Product Change Notice

Issue Date: 1-Dec-2021

New dice replacement for Leadframe Seven Segment Display and Annunciator.

Part identification:

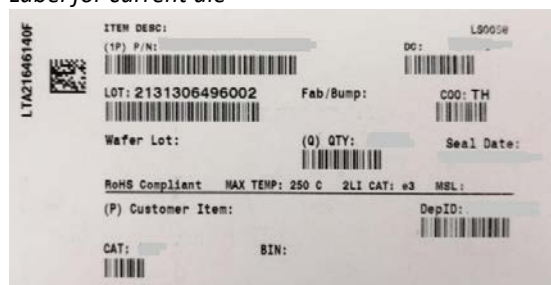
Label for current die

Label for new die

Prefix "E" will be added to the Lot number
